**Preliminary Alternative Technical Concepts (ATC) Submittal**  
**BEL-70-9.35 Interchange Improvement**  
**Design-Build**  
**Belmont County, Ohio**  
**PID 120547**

## Contents

**Figure 1** - Specified (Type 6) versus proposed (Type 2-A) curb configuration.

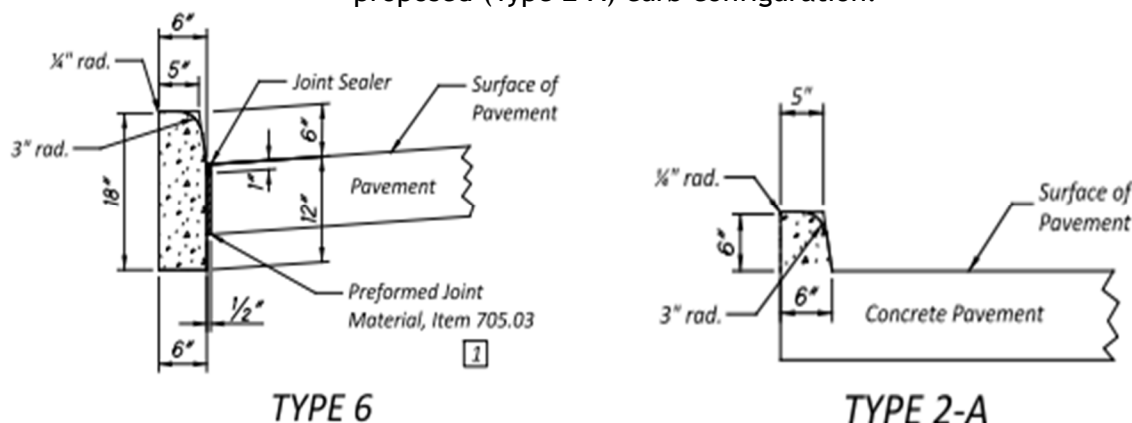
The DBT proposes changing the curb to Item 609E14000 - CURB, TYPE 2-A as shown in **Figure 1** below. This modification would improve production by allowing the curb to be paved with the pavement and eliminate the need for a separate activity with joints. This approach streamlines construction and potentially lowers costs, while maintaining the functional need for the curb.

2. **Deviation:** Page 37 of 63 of BEL-70-9.35, PID 120547 SCOPE OF SERVICES (Addendum 1) states: "All proposed curbing shall be Item 609E26000 - CURB, TYPE 6." Page 39 of 63 of BEL-70-9.35, PID 120547 SCOPE OF SERVICES (Addendum 1) states: "Curbing along SR-149 shall be Item 609E26000 - CURB, TYPE 6."

The DBT proposes to modify the above SCOPE OF SERVICES language to: **"All proposed curbing shall be Item 609E14000 - CURB, TYPE 2-A or Item 609E26000 - CURB, TYPE 6."** "Curbing along SR-149 shall be Item 609E14000 - CURB, TYPE 2-A or Item 609E26000 - CURB, TYPE 6."

Figure 2 - Minimum shoulder width for ATC 03 and Lane Widths per L&D manual

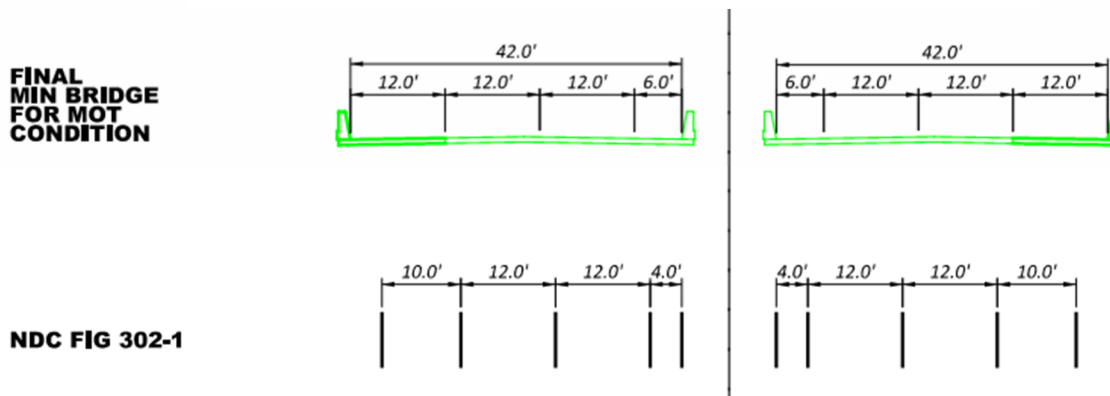
1. **Description:** This ATC proposes a modification to the dimensional requirements outlined on pages 44 and 45 of 63 of BEL-70-9.35, PID 120547 SCOPE OF SERVICES (Addendum 1). The original specification mandates shoulder widths in excess of ODOT Location and Design Manual Figure 302-1 requirements. The DBT proposes changing this requirement to design per the Location and Design Manual.

2. **Deviation:** Pages 44 and 45 of 63 of BEL-70-9.35, PID 120547 SCOPE OF SERVICES (Addendum 1) states for both SFN 0702227 and SFN 0702251: "Proposed minimum toe to toe of parapet - 46' (2 - 12' lanes, 1 - 10' median shoulder and 1 - 12' outside shoulder)."

The DBT proposes a modification of the above language to: "Proposed minimum toe to toe of parapet - 38' (2 - 12' lanes, 1 - 4' median shoulder and 1 - 10' outside shoulder)."

**Figure 3 - Type D barrier in front of the proposed bridge piers per conceptual plans**

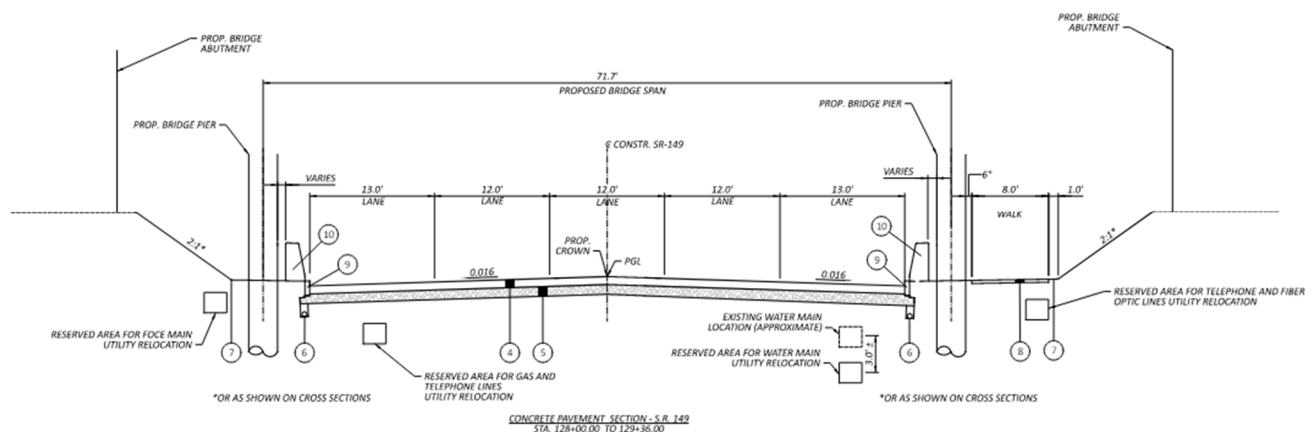
1. **Description:** This ATC proposes a modification to the pier design requirements outlined on Page 44 of 63 of the BEL-70-9.35, PID 120547 SCOPE OF SERVICES (Addendum 1). The original specification requires that piers be cap-and-column type and that their design must account for a 600-kip equivalent static force as described in AASHTO 3.6.5.1.

The proposed modification eliminates redundancy in the pier protection requirements. Page 39 of 63 of BEL-70-9.35, PID 120547 SCOPE OF SERVICES and the Conceptual Plans already mandate the installation of Item 622E10160 - CONCRETE BARRIER, SINGLE SLOPE, TYPE D on northbound and southbound SR-149 to protect the outside piers, with appropriate guardrail transitions and terminal assemblies. Given this existing protection, requiring the pier design to withstand a 600-kip equivalent static force per AASHTO 3.6.5.1 is excessive. Allowing the use of the Type D barrier in lieu of the 600-kip impact load ensures adequate protection while improving efficiency and as well as reducing cost and unnecessary structural reinforcement. The image below from the Conceptual Plans, P.7 of 133, TYPICAL SECTIONS - S.R. 149, CONCRETE PAVEMENT SECTION - S.R. 149 STA. 128+00.00 TO 129+36.00 shows the Type D barrier in front of the proposed bridge piers.

2. **Deviation:** Page 44 of 63 of the BEL-70-9.35, PID 120547 SCOPE OF SERVICES (Addendum 1) states: *"Piers must be cap-and-column type. Pier design is required to account for a 600-kip equivalent static force described in AASHTO 3.6.5.1."*

The DBT proposes to modify the above language to: *"Piers must be cap-and-column type. Pier design is required to account for a 600-kip equivalent static force described in AASHTO 3.6.5.1 or the use of Single Slope Barrier, Type D, per ODOT standards may be used to protect the piers in place of the 600-kip impact load."*

# EXHIBIT A

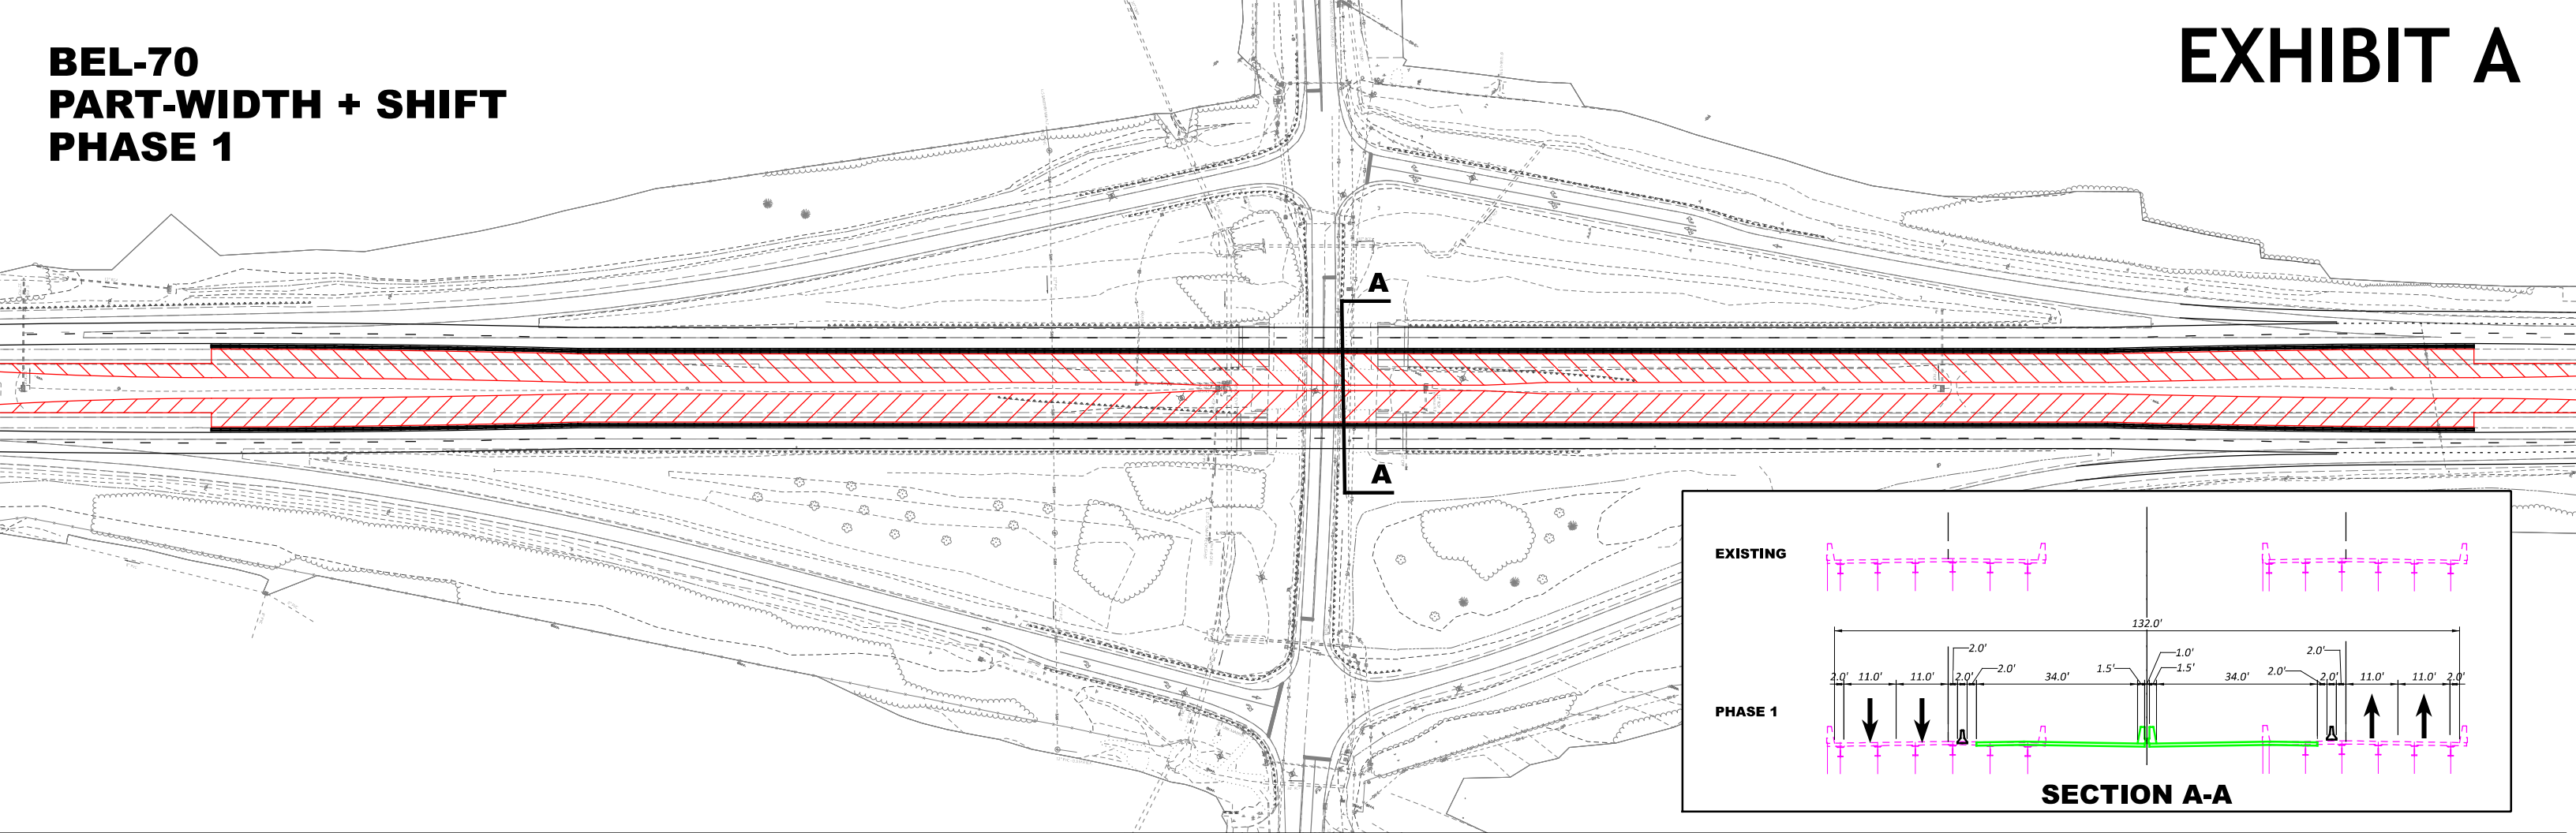
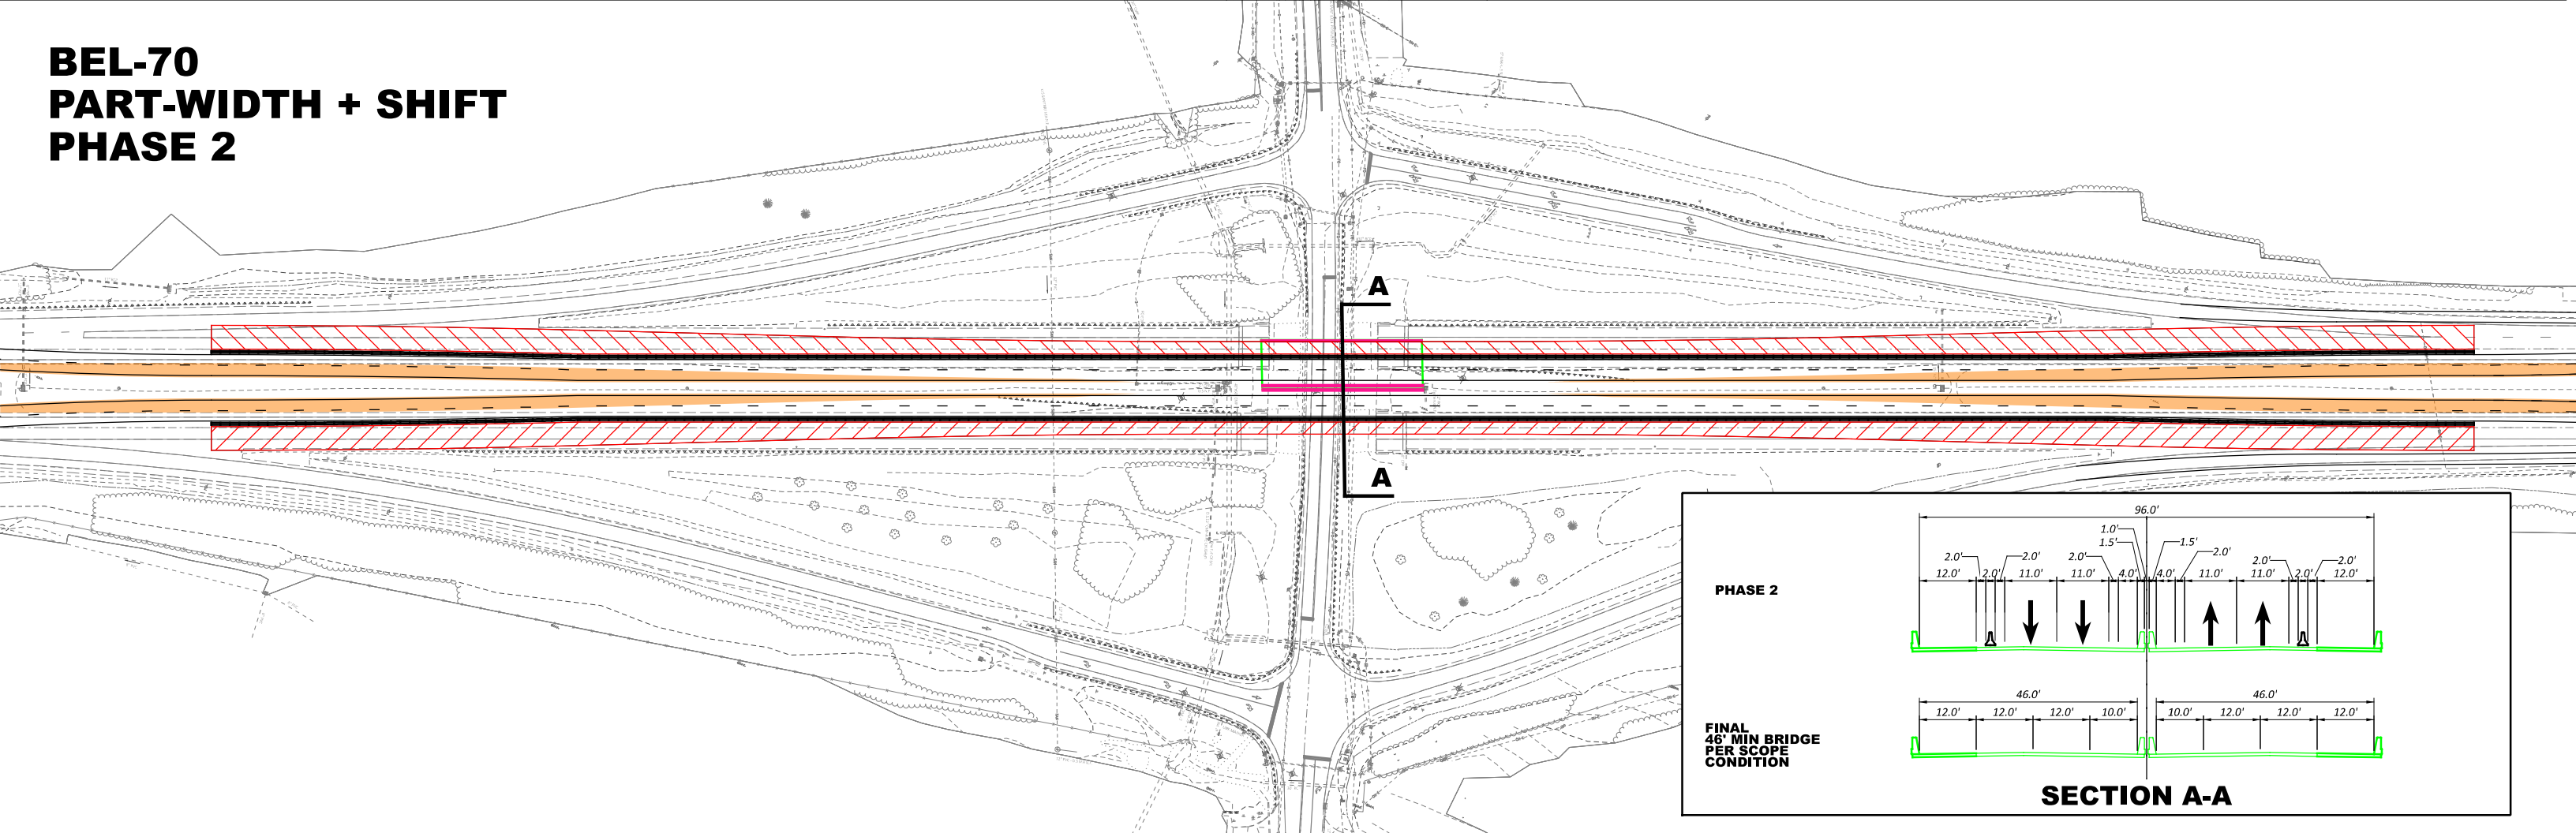
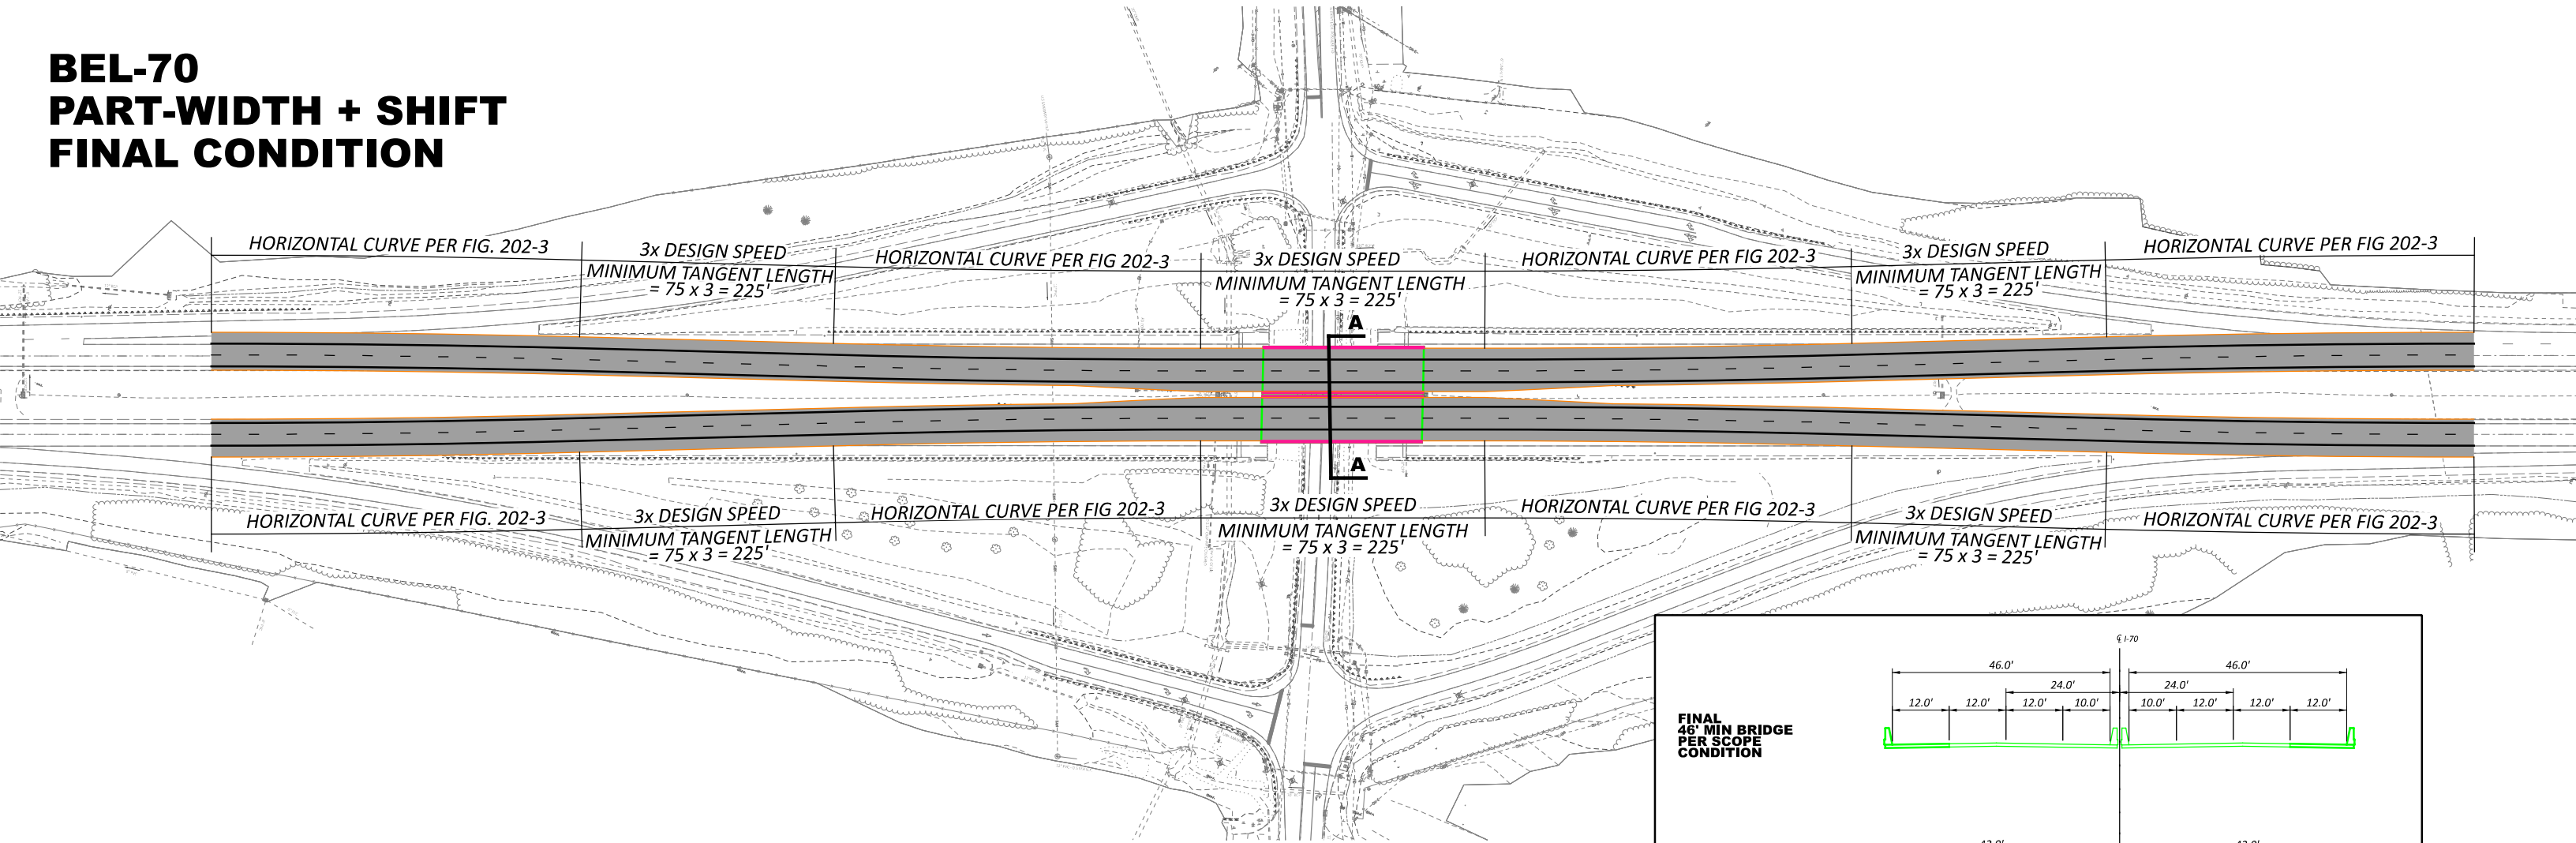
1. **Description:** This ATC proposes a modification to the dimensional requirements outlined on Page 38 of 63 of the BEL-70-9.35, PID 120547 SCOPE OF SERVICES (Addendum 1). The original specification mandates that the 42' dimension between the Centerline Survey IR-70 and the Centerline of WB and EB IR-70 lanes shall be held and not deviated from.

The DBT proposes modifying this requirement to align with the Location and Design Manual. This change enhances design flexibility, ensuring roadway alignment and geometry adhere to established standards while promoting safer traffic flow by eliminating contraflow and reducing phasing of the project construction.

This includes curves that are similar to curves for both the upstation and downstation of the project. DBT proposes to use 75mph design horizontal curves meeting L&D Vol 1, Fig 202-3 separated by tangents set to a minimum distance of 3x design speed. Record plans show 5729.58-ft radius Hz curves east and west of our project limits. The proposed permanent shift includes 15,000.00-ft radius curves separated by tangents set to a length of at least 3x design speed. See Exhibit A for additional details.

2. **Deviation:** Page 38 of 63 of the BEL-70-9.35, PID 120547 SCOPE OF SERVICES (Addendum 1) states: *"The 42' dimension between Centerline Survey IR-70 and the Centerline WB and EB IR-70 lanes shall be held and not deviated from."*

The DBT proposes to modify the above language to state: *"The dimension between Centerline Survey IR-70 and the Centerline WB and EB IR-70 lanes shall be designed per the ODOT Location and Design Manual and ODOT Bridge Design Manual."*
